RE: Review Comments, Puget Sound Energy's Preliminary Draft Report, "Reservoir Management Related to Imminent Flood Conditions"

The following joint comments are submitted on behalf of Mount Vernon, Burlington, Sedro-Woolley, and La Conner on the 20-page "Preliminary Draft Reservoir Management Related To Imminent Flood Conditions, July 11, 2011" report provided by Puget Sound Energy to the Baker Hydroelectric Project Aquatics Resources Group Tuesday, July 12, 2011. As you know, this is a vitally important matter to our cities.

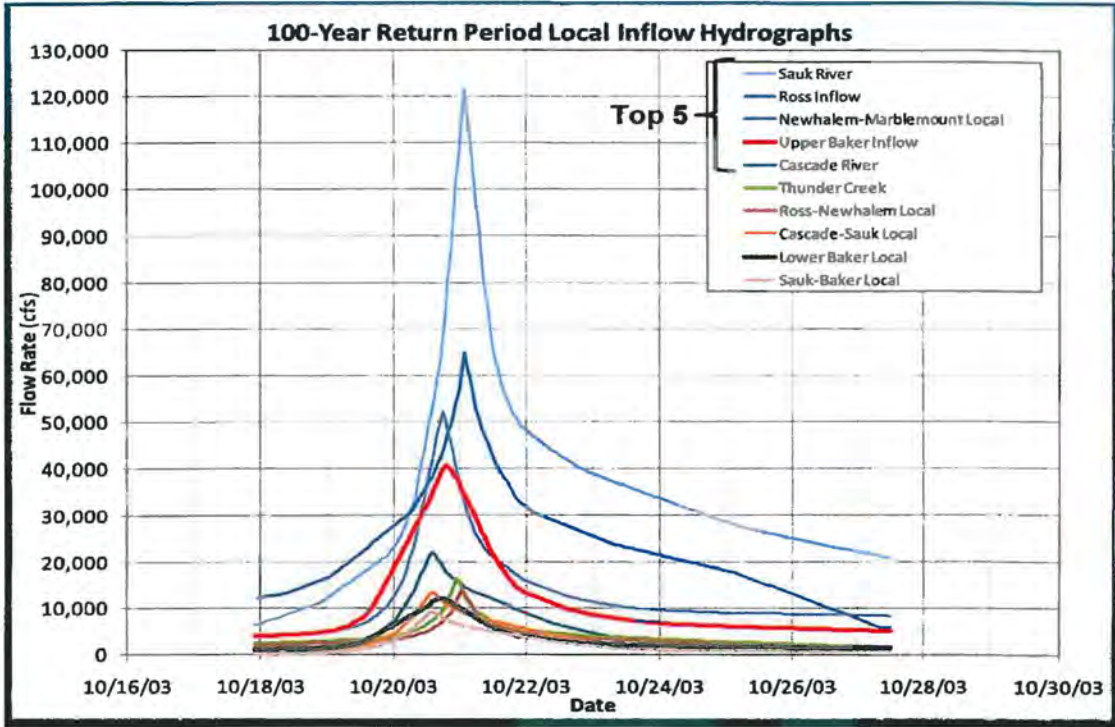
1. Slide #4 of 55, Study Objectives: Add a second bullet to the first objective, "Maximum flood benefits = zero Project outflow 10 hours before and 10 hours after the Skagit regulated flood peak at Concrete."

2. Slide #6 of 55, Study Objectives: Add an additional bullet after the second bullet, "Can the Project be operated in a way that will help retain natural flood storage in the downstream Nookachamps basin?" (Note: this can be done if the Skagit flow is maintained below 57,000 cfs)

3. Slide # 12 of 55, Inflow Hydrographs: this is a good and useful graphic. Conveys a lot of information relevant to the analysis. As do the graphics on slides #7 and #8. It would be useful to "stretch out" the interval shown so that it is easier to estimate the timing differences of the flood peaks of the various basins. The graphic could start, for example, on 10/18 and then go until 10/24. It also might be helpful to show a vertical line representing the timing of the Skagit peak flow at Concrete.

4. Slide #13 of 55, Analytical Periods: It would be nice to simplify this. One way that the analysis could be simplified would be emphasize Lower Baker, as that will focus the analysis more on the constraints that affect releases from Lower Baker. Of course the Upper Baker storage is very important, but the real issue is outflow from Lower Baker.

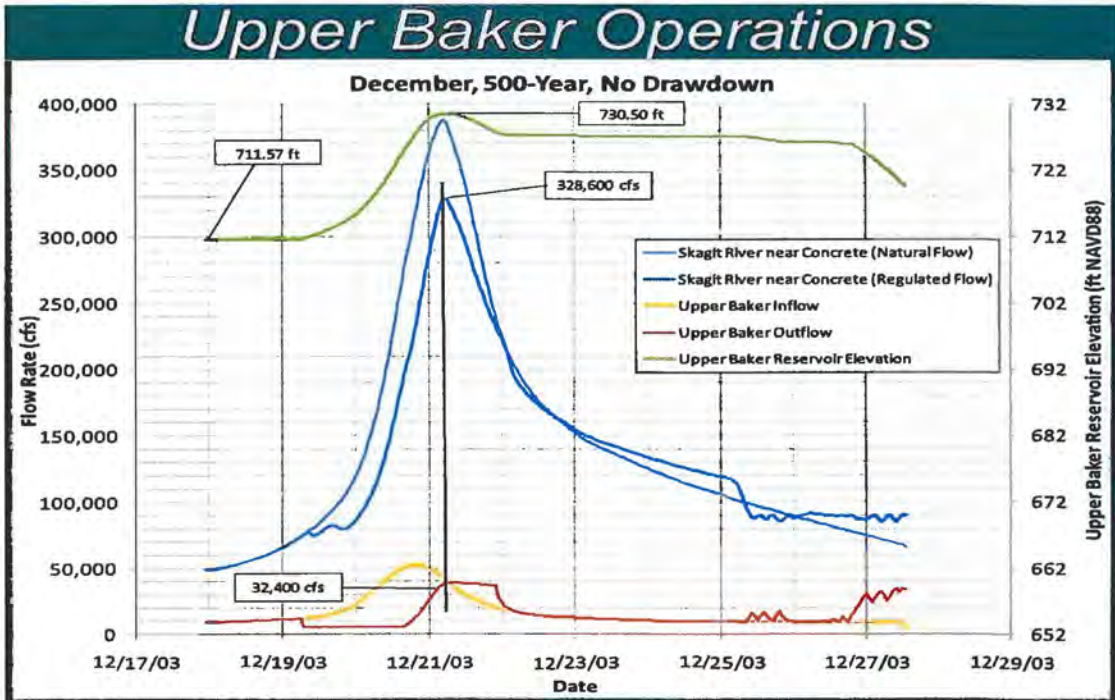
5. Slide #22 of 55, Upper Baker 500-year Ops: It is not clear to me what the 32,400 cfs annotation applies to. It appears to indicate the outflow of Upper Baker at the Skagit flood peak; however, it appears that outflow would be about 38,000 cfs from the graphic.

6. Slide #23 of 55, Lower Baker 500-year Ops: is this right? If the 500-year inflow to Lower Baker from Upper Baker, at the time of the Skagit flood peak, is about 38,000 cfs, it seems like the inflow from Lower Baker's basin would be 12,000 cfs or more at the same time, for a total closer to 50,000 cfs.

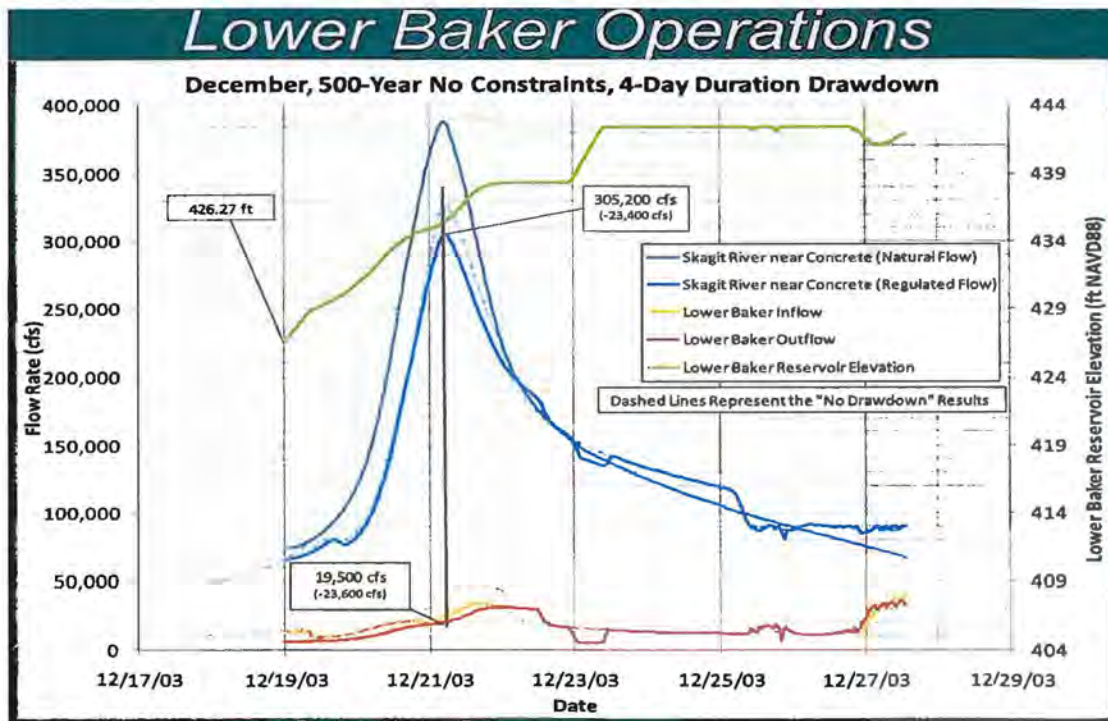
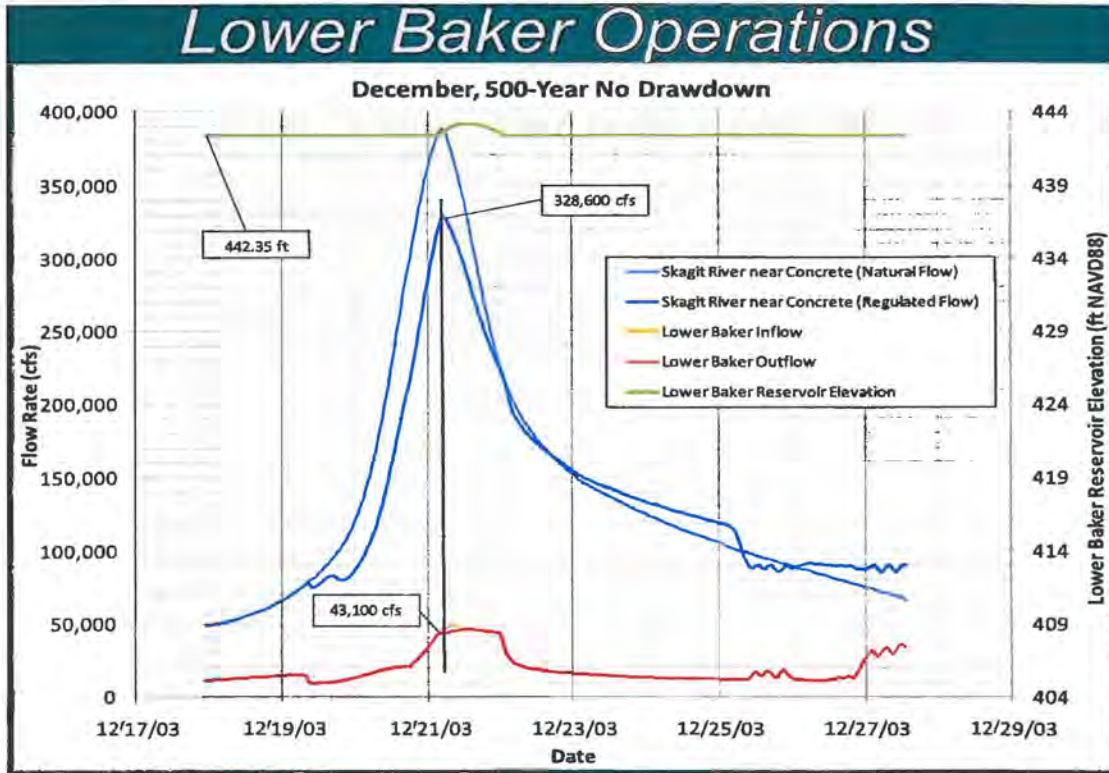
7. Slide #25 of 55, Lower Baker 500-year Ops: although it would not make much downstream difference in a flood of this magnitude, I would note that Lower Baker could still be used to reduce the Skagit peak by another 10,000 cfs or so, because the reservoir would still have some small amount of storage available prior to the Skagit flood peak and Concrete. This could be done by monitoring the flood peak on the Sauk above Whitechuck gage, as well as the Sauk gage, and then reducing outflow from Lower Baker shortly after the Sauk above Whitechuck gage crests, if it looks like the Sauk gage is rate of increase is slowing. There is an art to this but it can be done.

9. Slide #40 of 55: This slide is difficult to understand. I think I understand that under dry antecedent conditions, it would be possible to achieve about 93,000 acre-feet of flood storage in Upper Baker, subject to license constraints as you have defined them (and lower amounts for wetter precedent conditions)?

Comparison of Skagit River near Concrete Regulated Peak Flow Rates  
 No Drawdown vs. Drawdown  
 December Dry Antecedent

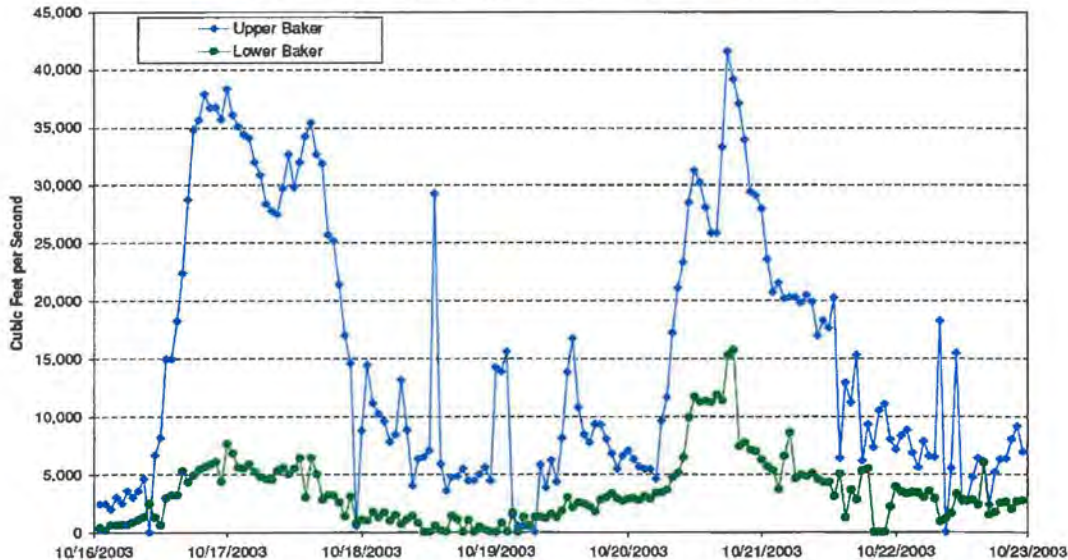
12. Slide #43 of 55: This slide is deceptive and should be changed. The change is: add a center sub-column in each of the main columns for 4-day drawdown and 4-day alternative drawdown, entitled "Project Outflow" and include those numbers in the center column for each drawdown scenario.

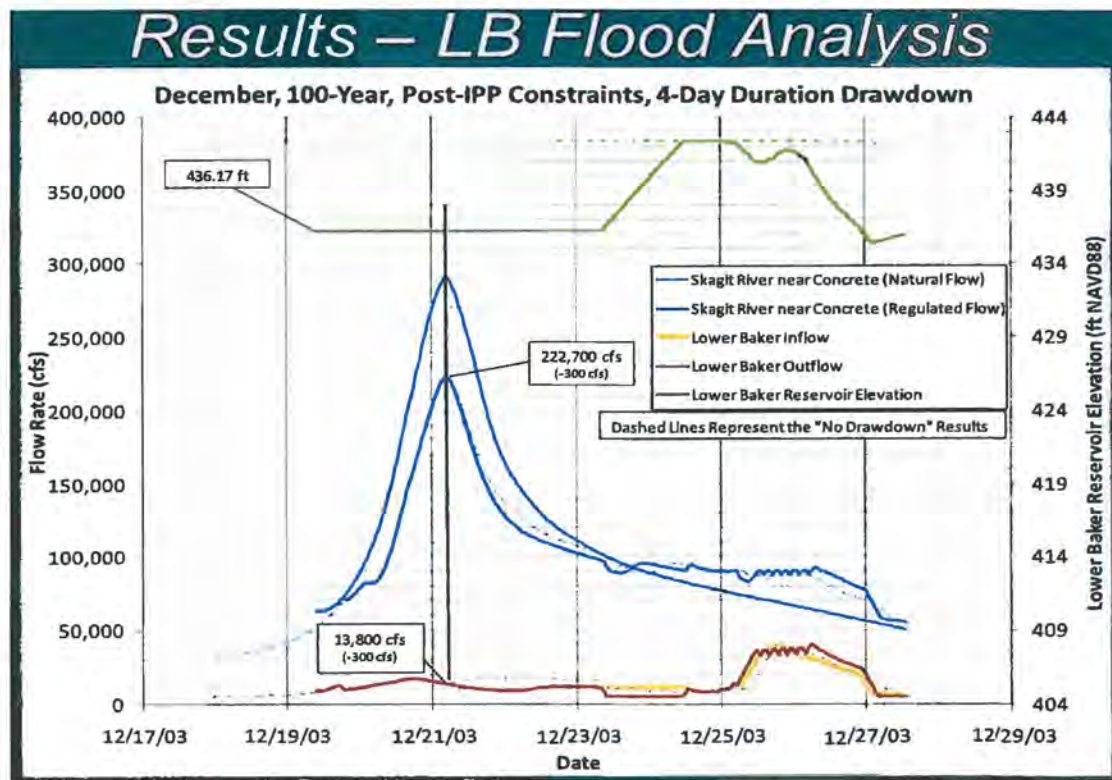
13. Slides #48 and 49: These two slides are very important and key to the analysis. Of note is the fact that Lower Baker releases approximately 14,000 cfs into the Skagit flood peak, while significant storage is still available in Lower Baker reservoir. Side note: I assume 14,000 cfs represents 5,000 cfs inflow from Upper Baker and 9,000 cfs natural inflow into Lower Baker. This seems low for a 100-year flood event. Below is the graphic showing inflow during the double pump October 2003 flood, generally considered to be about a 30 year event for the Skagit:

14. Slides 48 and 49: add another slide to this group showing the impact of reducing project outflow to zero for a 20-hour period beginning 10 hours prior to the flood peak at Concrete. This analysis may extend upstream to the Upper Baker reservoir, to the extent additional flood storage may be available in that reservoir that could be used to retain storage in Lower Baker.

# Results – LB Flood Analysis

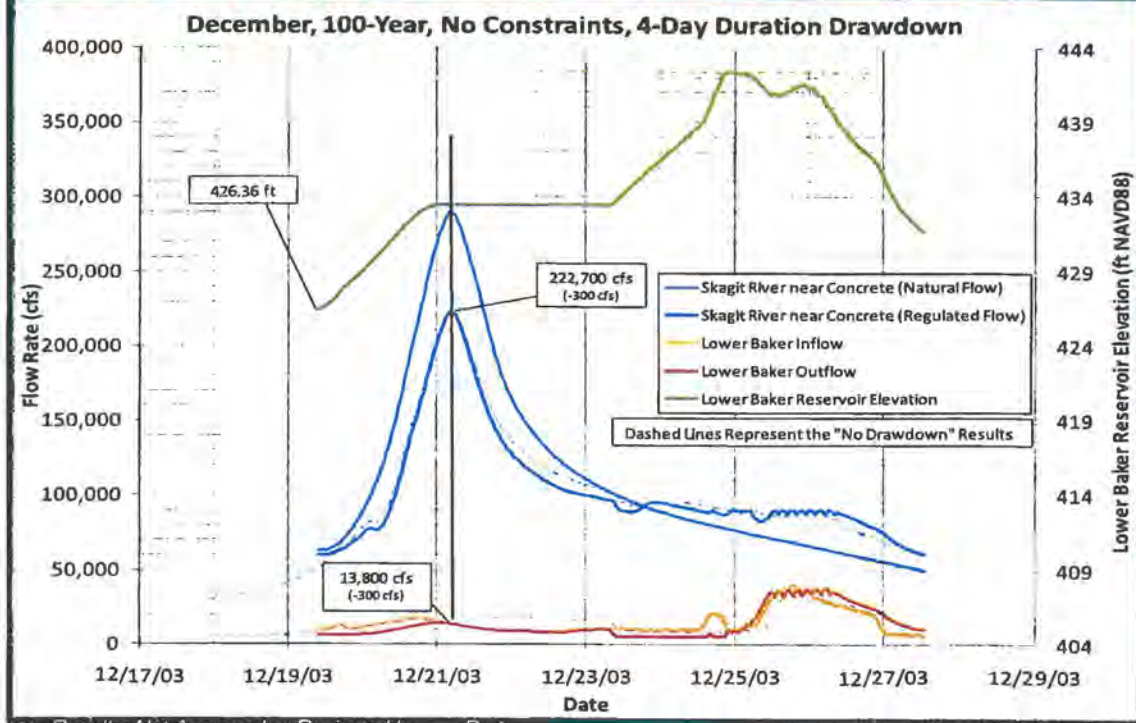
15. Slides #50-52: These three slides need to be modified to include the analysis showing the peak flow impact on the Skagit of reducing project outflow to zero during a window of time beginning 10 hours prior to the Skagit flood peak and extending 10 hours beyond the Skagit flood peak.

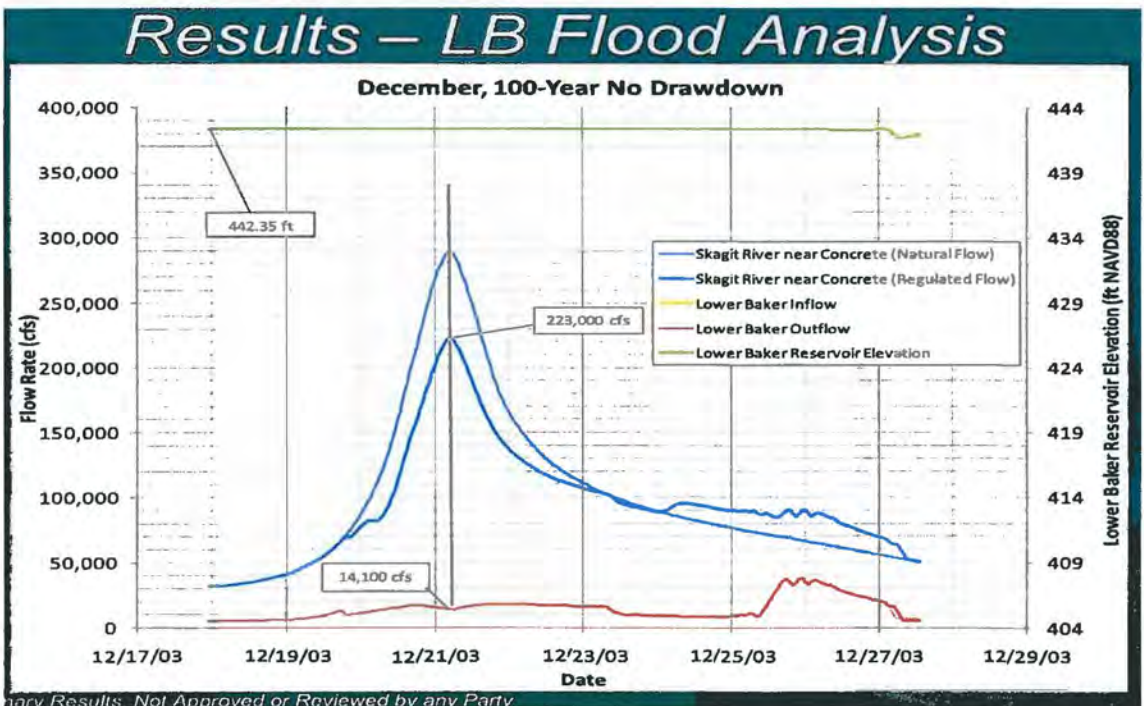
Comparing slides 49 and 51 with slide 39 (shown below) is confusing. I think I understand that for the smaller flood events occurring early in the flood season, prior to any substantial availability of flood storage, that the beneficial effect of drawing down the reservoirs is more pronounced. But in slide #39 below, the underlying assumption, which I pointed out I do not agree with, is that the peak

flow reduction is based on the "constraints" of minimum 5,000 cfs generation from Upper Baker, and also passing all of the natural inflow from Lower Baker.

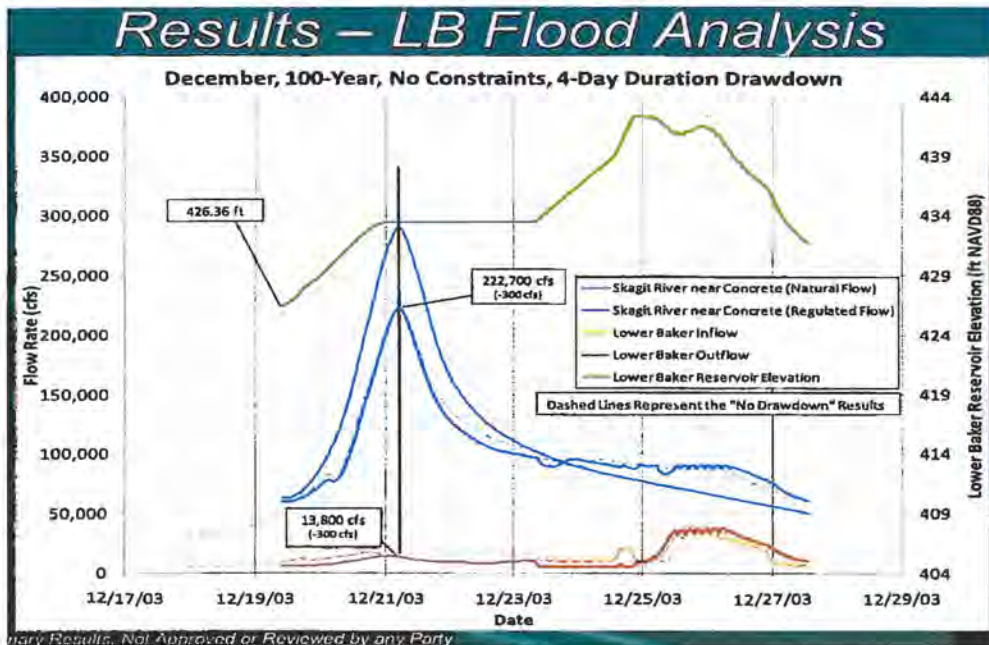
First, the graphics above indicate that the synthetic hydrograph of the Lower Baker inflow (because the assumption is: inflow = outflow) is about 9,000 cfs for a 100-year Skagit flood event at the timing of the Skagit's peak at Concrete. Is this correct? It seems a little low for a 100-year event.

Then, comparing slide 49 with 39, and after correcting the peak flows to regulated numbers, is there also an assumption for slide 49 (Oct 1-20) of 5,000 cfs generation into Lower Baker, plus passing inflow into Lower Baker? I am trying to estimate the numbers: assuming the 22,700 cfs delta for a 25-year event should be reduced to about, say, 17,000 cfs to account for regulation, and then adding 5,000 cfs for generation from Upper Baker and, say, 5,000 cfs from Lower Baker's natural inflow, this would mean that without the drawdown, the Baker project would be spilling 27,000 cfs into the flood peak. Is that correct?
